CONVAIR
A Division of General Dynamics Corporation
San Diego, California

COMMERCIAL CHANGE PROPOSAL

SPNO NO: ZD-22-003 DATE: _____
CUSTOMER: Delta Air Lines Inc. MCL 10,158 Dtd _____
CHANGE NO: 100 MODEL: (880) 22-2

TITLE: **Tinted Interior Cabin Windows, Installation of**

PAGE
REPORT NO.
MODEL DAL.
DATE 10-4-57

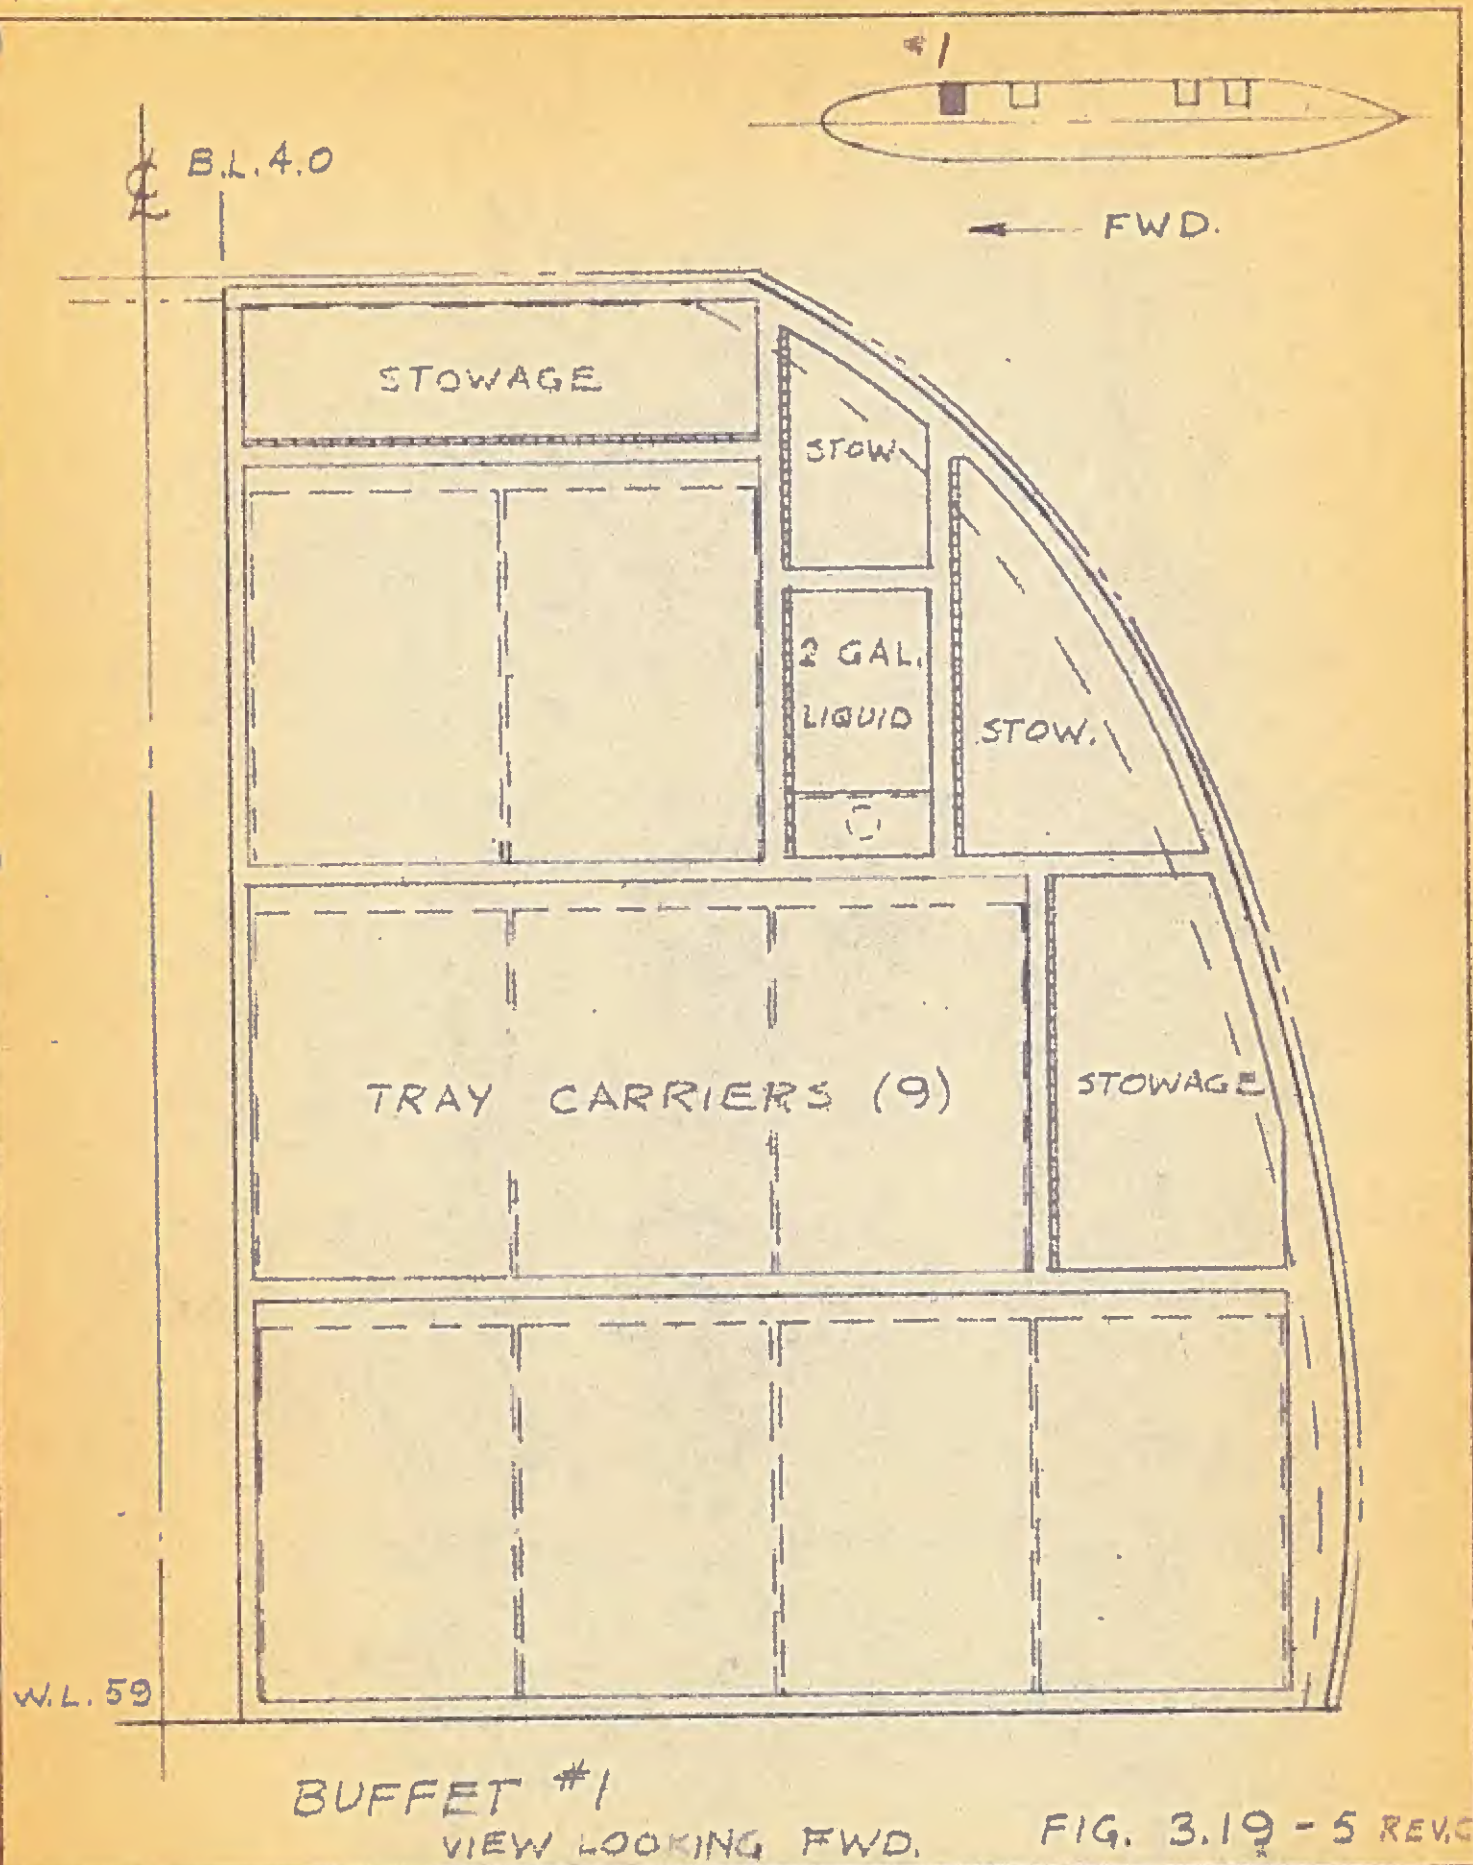
Enclosures: (A) Four (4) copies Figure 3.19-5 Revision C
(B) Four (4) copies Figure 3.19-6 Revision C
(C) Four (4) copies Figure 3.19-6A Revision A
(D) Four (4) copies Figure 3.19-7 Revision A, Alt. B

Figure 1-2 - Inboard Profile and Plan View and
Figure 1-3 - Alternate Seating Arrangement, will be revised in
accordance with this Change No. 35B as follows:

II. Right hand movable coat rack will be provided as loose equipment.

III. Convair will use a total of 614 pounds for Customer food service in Convair useful load calculations.

12-PLACE CLUB AREA

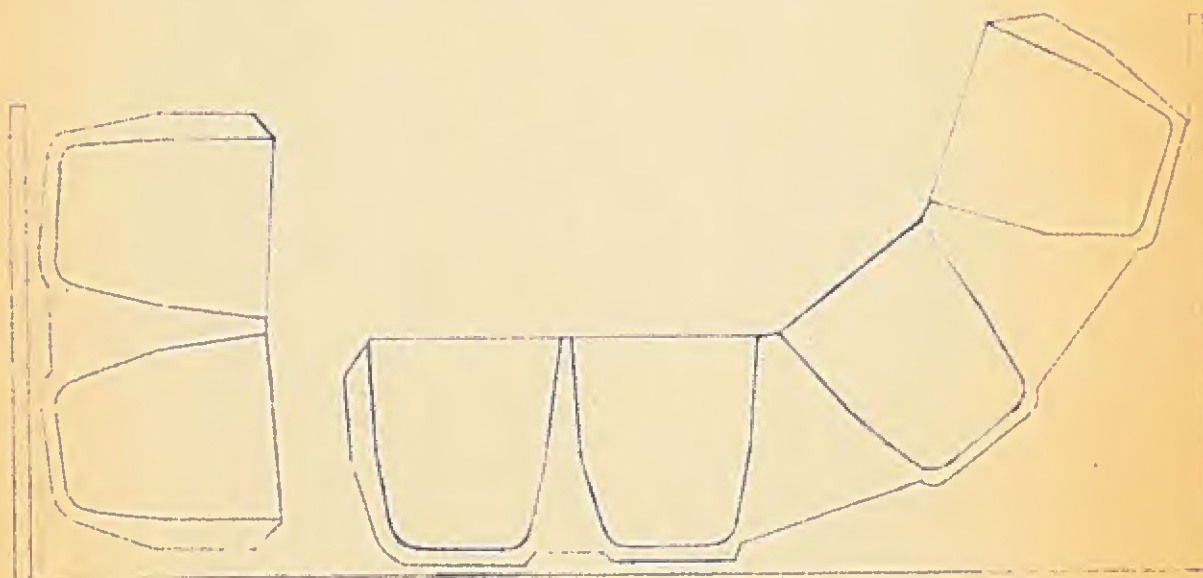
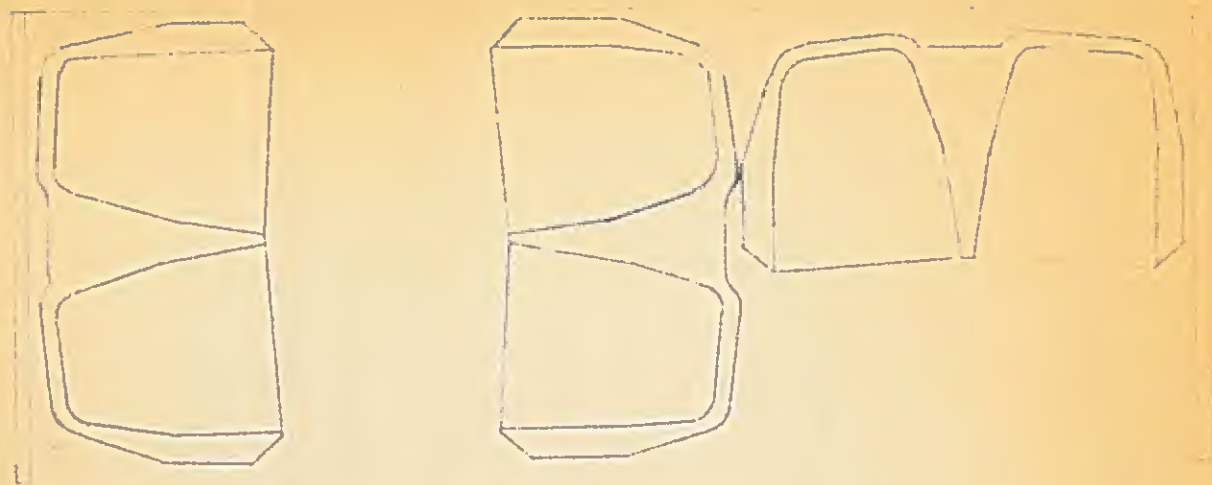
Figure 1-2 - INBOARD PROFILE AND PLAN VIEW
Figure 1-3 - ALTERNATE SEATING ARRANGEMENT
Figure 3.7-1 - EMERGENCY EXIT FLOW
Figure 3.19-4 - HIGH PRESSURE OXYGEN GAS SYSTEM SCHEMATIC

Revise above figures as required to reflect change.

Enclosure: (A) One (1) copy of sketch of proposed Club Area Arrangement.
